Project	IEEE 802.16 Broadband Wireless Access Working Group < http://ieee802.org/16 >	
Title	Optimized Distributed Bandwidth Request and Allocation in 802.16j system	
Date Submitted	2007-04-25	
Source(s)	Shulan Feng, Yanling Lu, Ting Li ,Liangliang Zhang Hisilicon Technologies Harbour Building, No.8, Dongbeiwang West Road, HaiDian District, Beijing, China	Voice: 86-10-82829010 Fax: 86-10-82829075 mailto:luyanling@hisilicon.com, fengsl@huawei.com
	Masato Okuda and Yuefeng Zhou Fujitsu	mailto:okuda@jp.fujitsu.com Yuefeng.Zhou@uk.fujitsu.com
Re:	This contribution is a response to " IEEE 802.16j-07/013 Call for Technical Comments regarding IEEE Project 802.16j" (2007-04-02) .	
Abstract	This contribution describes a proposed distributed scheduling in 802.16j system.	
Purpose	This document is provided in response for Call for Technical Comments and Contributions regarding IEEE Project 802.16j .	
Notice	This document has been prepared to assist IEEE 802.16. It is offered as a basis for discussion and is not binding on the contributing individual(s) or organization(s). The material in this document is subject to change in form and content after further study. The contributor(s) reserve(s)

Figure 1 Periodic Bandwidth Grant with RS_SCH_IE

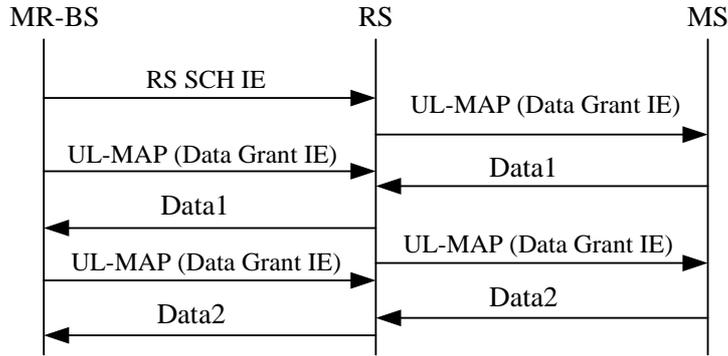
In MR system with distributed scheduling, the MR-BS or a RS may send its RS SCH IE in advance to its subordinate RS, to indicate when and how much bandwidth it will schedule for the real time service in the future. The RS SCH IE includes the CID on which the user traffic is carried, the frame offset to indicate when the bandwidth will be granted and the size of bandwidth allocation. The actual grant is issued using Data Grant IE as defined for single hop case. For periodical bandwidth grant, RS SCH IE could be sent just once.

RS SCH IE is generated by the MR-BS or a RS and sent to its subordinate RS until the MS's access station is reached. Figure 1 illustrate the bandwidth grant procedure using RS SCH IE.

Figure 2 Periodic Polling with RS_SCH_IE

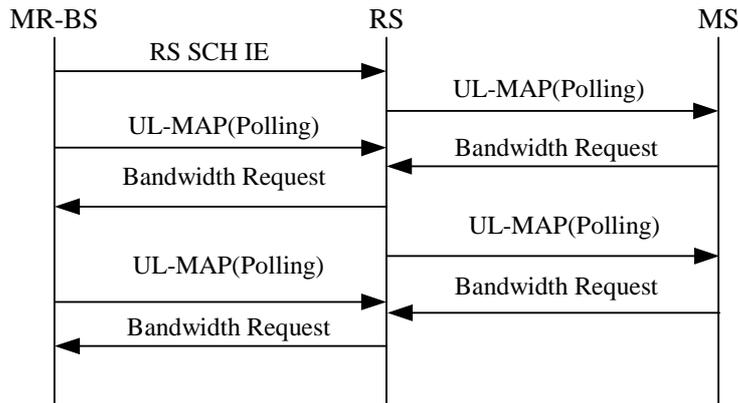
Similar to the bandwidth grant, the periodic polls issued by the MR-BS or a RS to its subordinate RS may be accompanied with a RS_SCH IE. The RS-SCH-IE is generated by the MR-BS or a RS and sent to its subordinate RS until the access RS is reached. Figure 2 illustrates the polling procedure using RS_SCH IE.
